TOLEDO CITY PLAN COMMISSION

*REPORT
December 1, 2022*

SITE PLAN

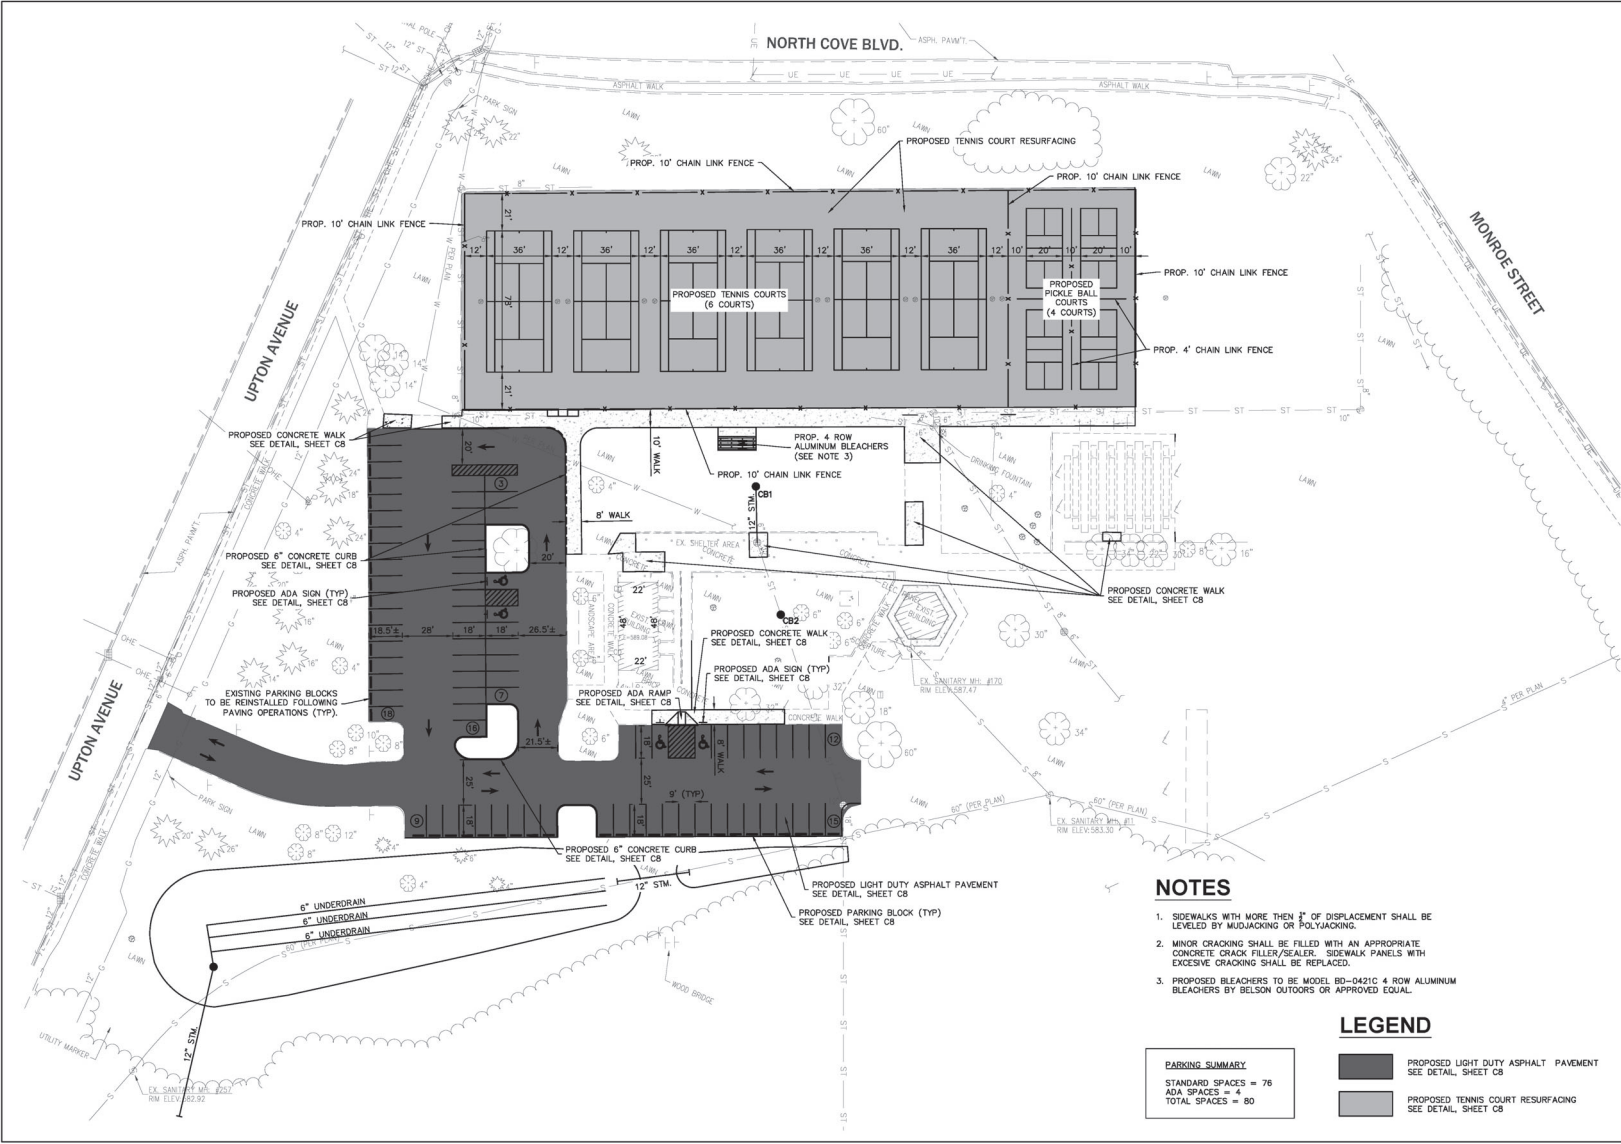
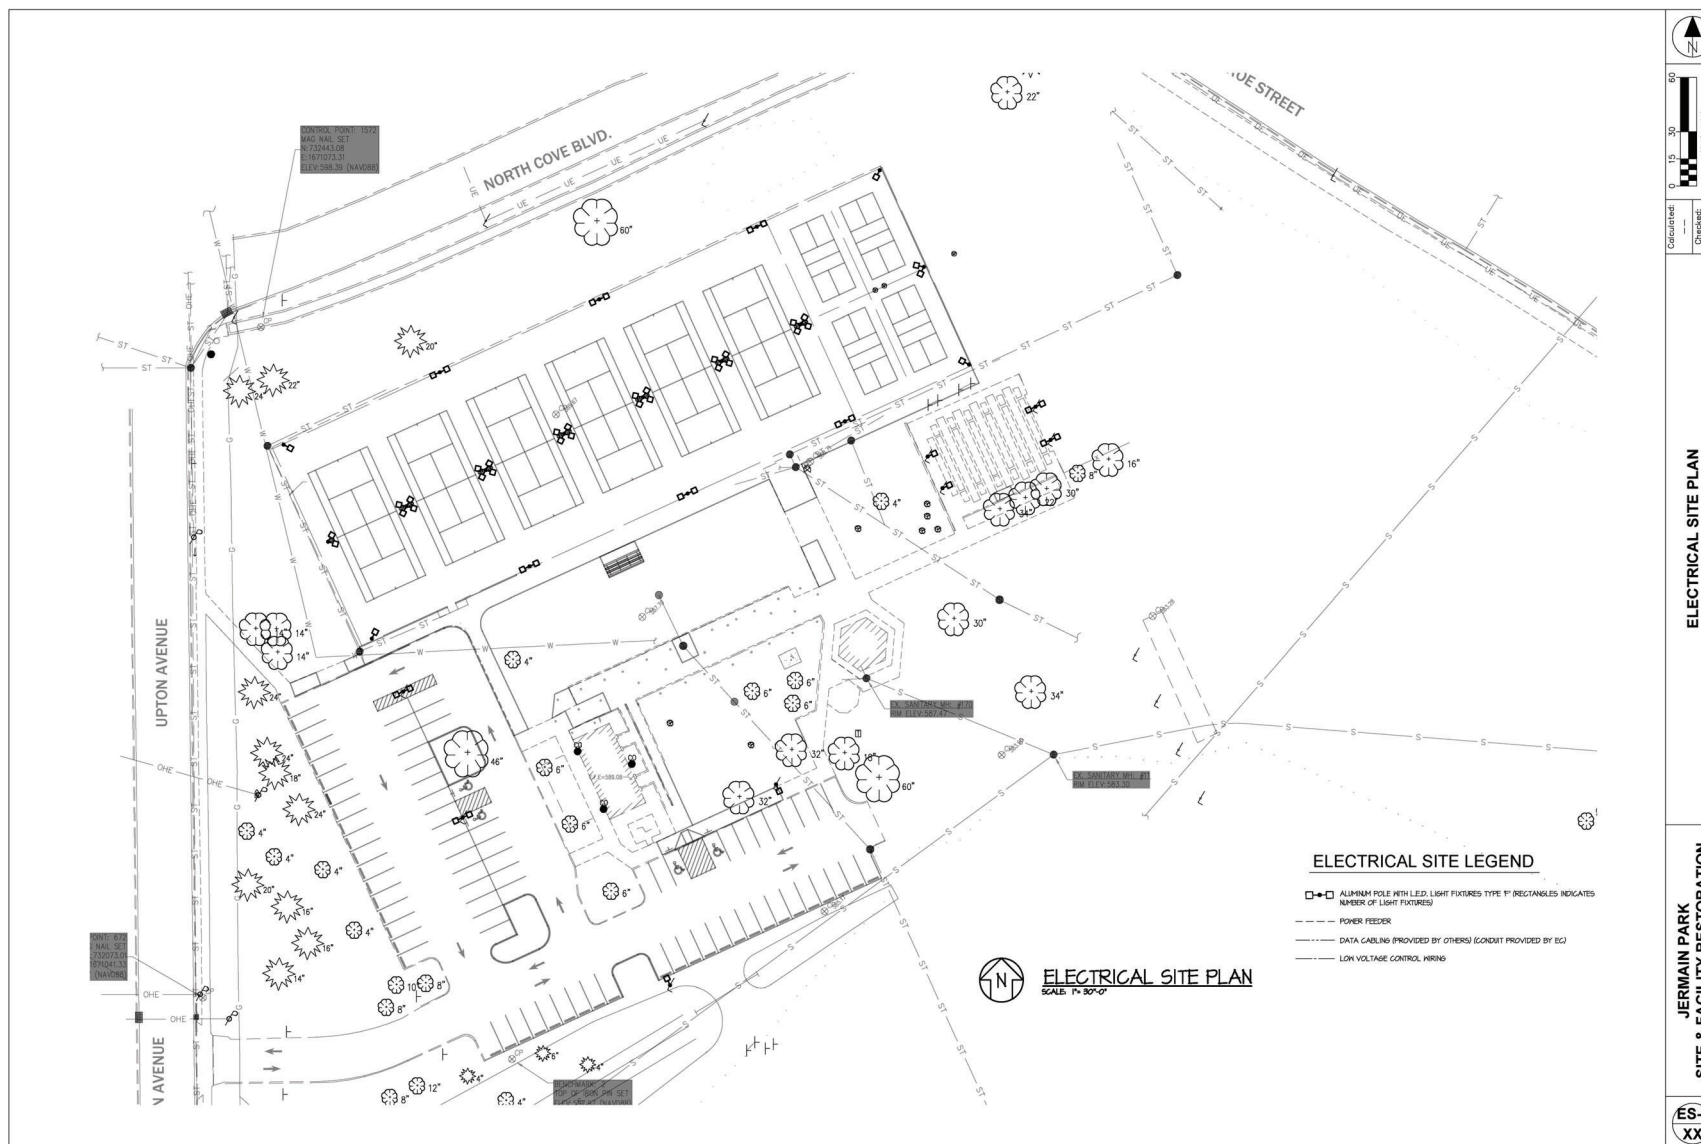
Minor revisions to existing parking layout are proposed. Drive aisles, entrances, and parking spaces will maintain similar layouts to the existing. Four parking spaces have been removed from the site to provide a landscape island at the end of the central parking row. A total of eighty (80) parking spaces are provided. Pursuant to TMC§1107.0600 – Off-Street Parking Schedule “D”, Community Recreation facilities have a wide variety of parking demand characteristics making it difficult to specify a single off-street parking standard. The reduction in parking spaces reflects the reduction in total recreation courts provided. The site is designed in such a way as to provide ample space for expansion should parking demand outpace available spaces. As a condition of approval, the applicant shall be required to address parking overflow in the event demand exceeds available parking on a regular basis so as to become a nuisance.

A portion of the total number of required off-street parking spaces must be specifically designated, located, and reserved for use by persons with physical disabilities. According to the table in TMC§1107.1701 – *Number of Required Parking Spaces for Persons with Disabilities*, the applicant is required to provide at least one (1) van accessible space with an eight-foot (8') drive aisle and three (3) car accessible spaces with five-foot (5') drive aisles for persons with physical disabilities. The site plan provides four (4) van accessible spaces.

Bicycle parking is required pursuant to Off-Street Parking Schedule “A” (TMC§1107.0300). A minimum of one (1) bicycle space shall be provided per ten (10) automobile parking spaces. The proposed plan requires eight (8) bicycle parking spaces. Upon a site visit, planning staff confirmed the presence of some bicycle parking on site. The total quantity of bicycle parking, with a minimum of eight (8) slots, shall be shown on a revised site plan.

Additionally, there must be safe, adequate, and convenient arrangement of pedestrian walkways, bikeways, roads, driveways, and off-street parking and loading spaces within off-street parking areas. The proposed plan allows pedestrian access to the site from Upton, as well as internal circulation between amenities. The swale to the south of the parking lot is designed in such a way as to allow access to the mountain-bike path from the parking lot.

SITE PLAN MAGNIFIED

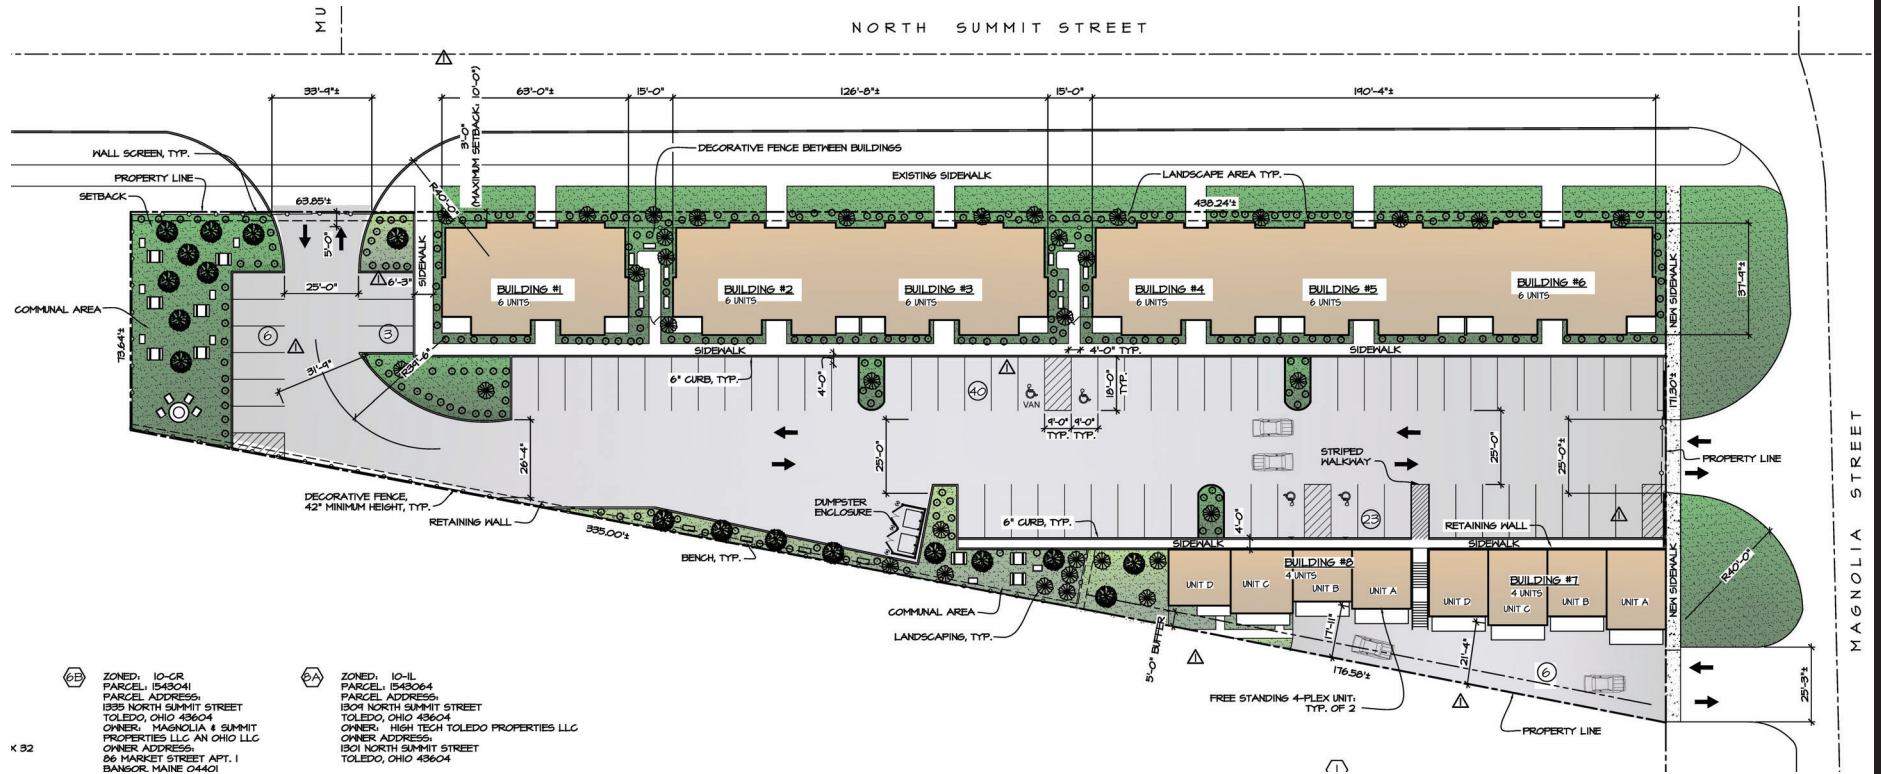
36. Two (2) car accessible and one (1) van accessible space are required. **Acceptable as depicted.**
37. Parking spaces reserved for the use by persons with physical disabilities shall adhere to the standards outlined in TMC§1107.1700. **Accessible parking spaces serving the Bungalow units shall be moved nearer to the property line abutting Magnolia, as the proposed staircase does not provide accessible access to said units.**

38. The maximum building setback is ten-feet (10') along Summit Street. **Acceptable as depicted.**
39. Bicycle parking slots shall be provided pursuant to Off-Street Parking Schedule "A" (TMC§1107.0300). One bicycle parking slot shall be provided per every ten (10) parking spaces for a total of seven (7) spots. Given the urban context of the site and proximity to bicycle trails, the applicant is encouraged to include additional bicycle parking required beyond the minimum. **None depicted. Seven (7) spaces shall be shown on a revised plan.**

44. A revised site plan shall depict a clear method of access to the consolidated outdoor area.
